COPPERSTRING EIS

Attachment F - Vegetation Clearing Works plans

Dajarra Road to Mount Isa

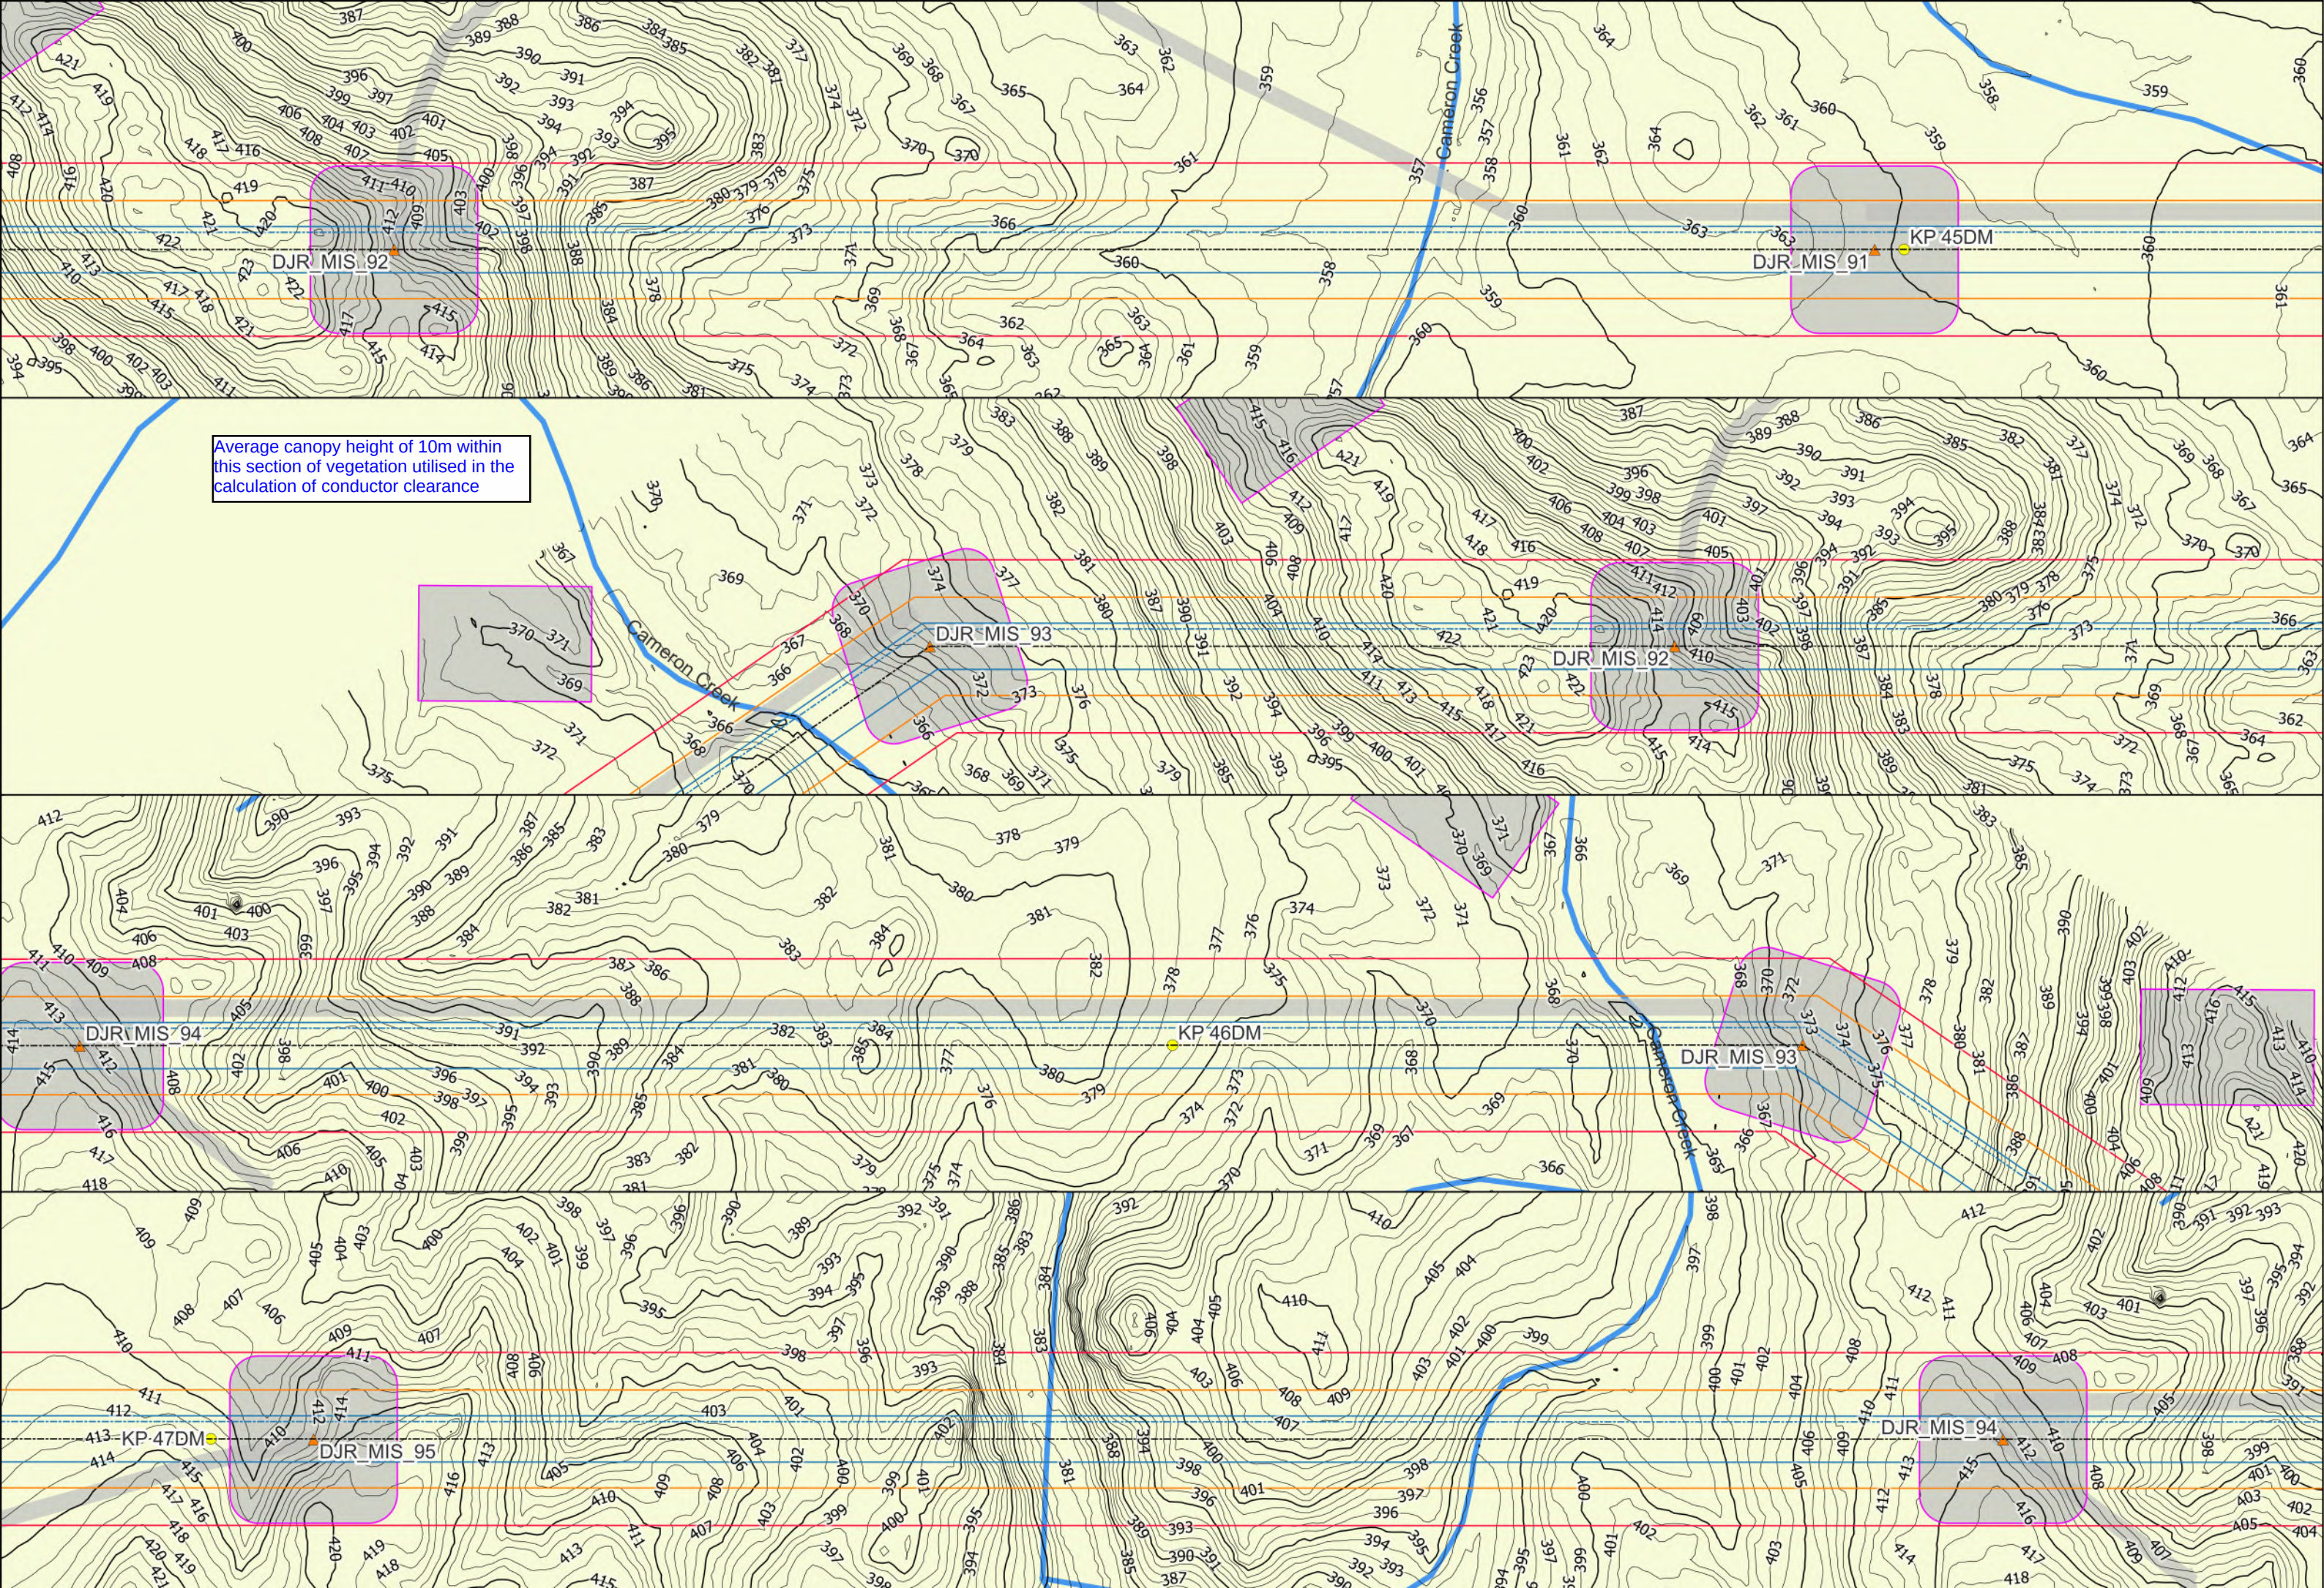
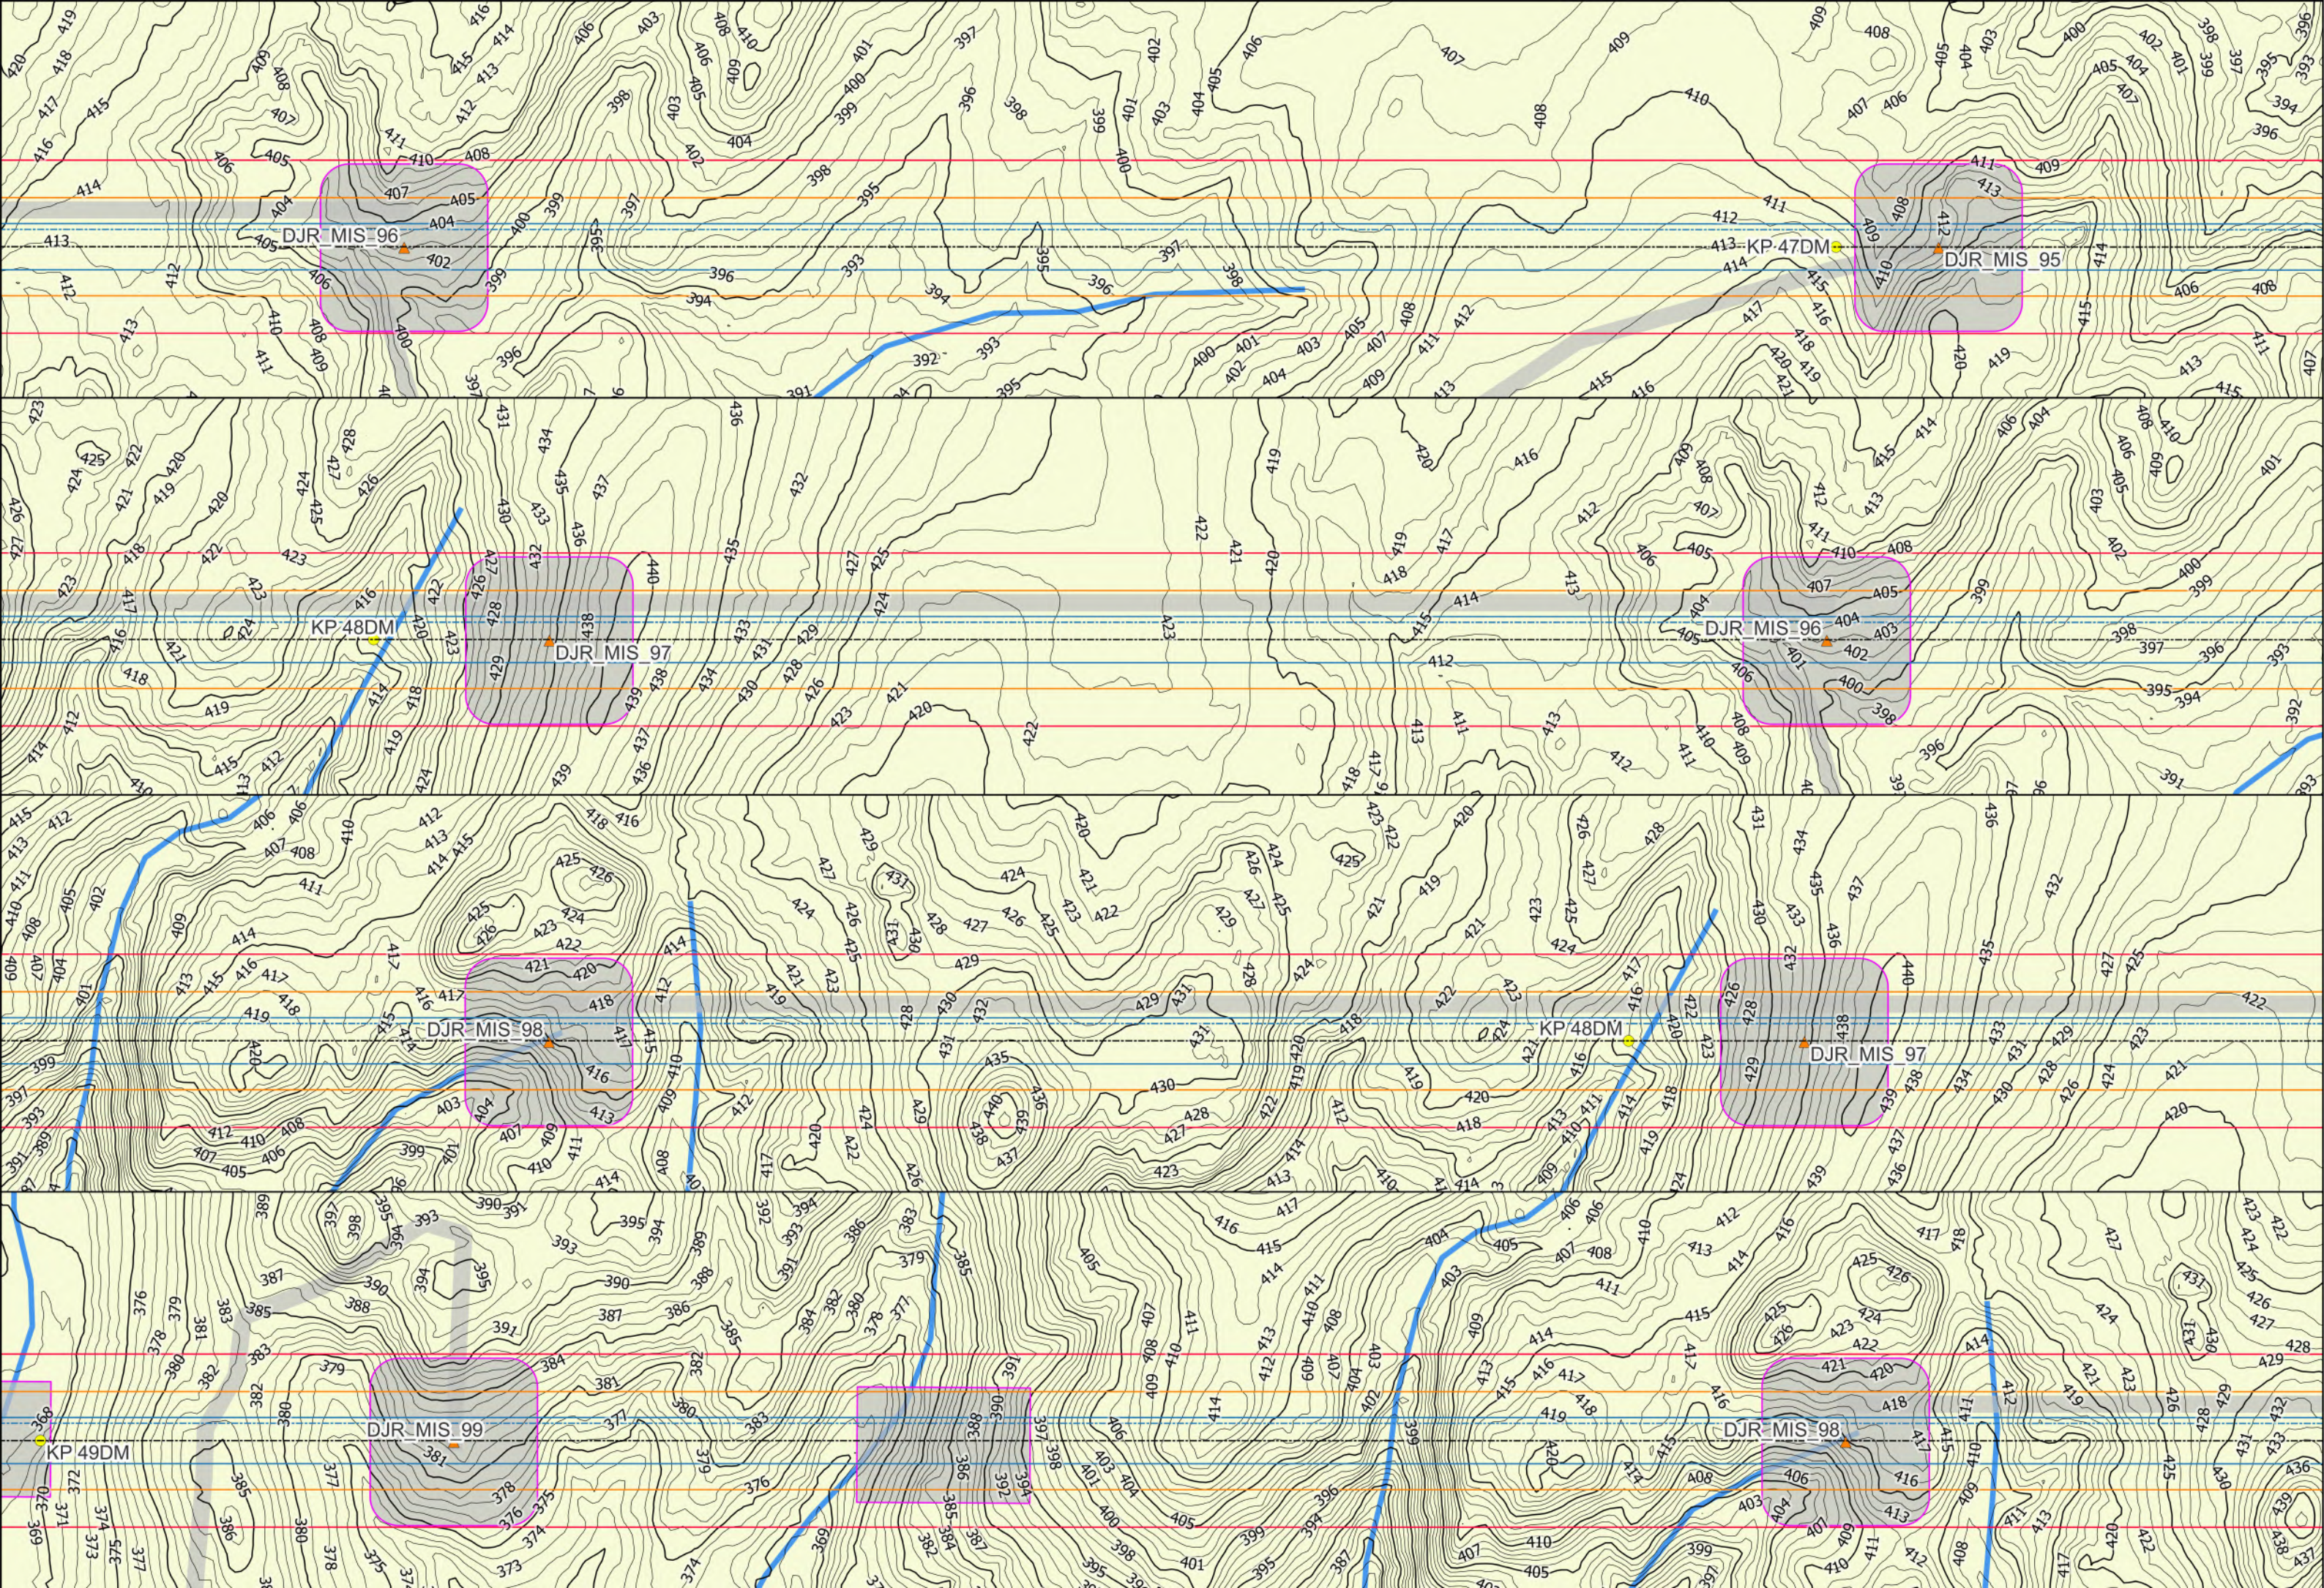
Average canopy height of 10m within this section of vegetation utilised in the calculation of conductor clearance
